Access Compliance Report Public Rights-of-Way (Curb Ramps)

Main Street: ORANGEWOOD_AVE Cross Street: LOS_ALAMITOS_BLV Location: NW

ADA ID: RPRK211217120529 Ramp Type: Type 1 - Perpendicular Diagonal Initial Pass/Fail: Pass Overall Compliance: No Severity Score: 5

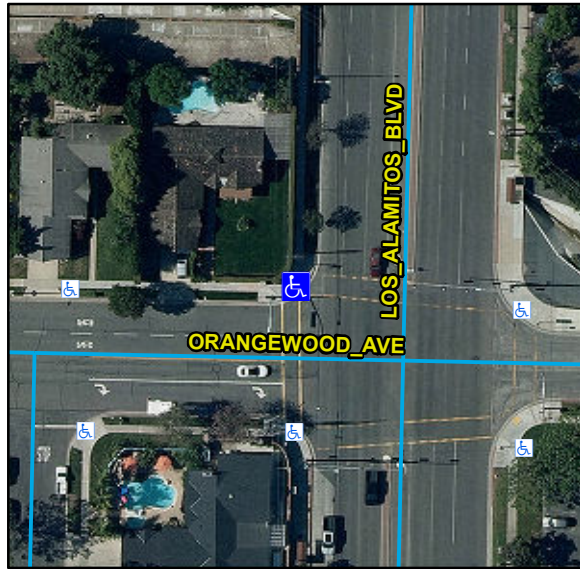
Yes	Ramp Inside Crosswalk 1	Yes	Yes	Ramp Inside Crosswalk 2	Yes
	Crossing 1 Slope (%)	2.4		Crossing 2 Slope (%)	5.2
	Crossing 1 Cross Slope (%)	2.7		Crossing 2 Cross Slope (%)	3.3
Yes	Gutter Ponding	No	No	Curb Slope	5.7
Yes	Gutter Lip Height (in)	0		Road Run Slope (%)	3.2
No	Gutter Run Slope (%)	12.2		Road Cross Slope (%)	4.3
Yes	Gutter Cross Slope (%)	0.5			
Yes	Overall Surface Condition: Acceptable		Yes	Perp Joint Present	Yes
	Cross Gutter Present?	No		Spandrel Present?	No
	Replace Cross Gutter?	N/A		Replace Spandrel?	N/A

Remove & Replace Curb Slope. Remove & Replace Gutter.

R304.2.2, R304.5.4, STD 1115
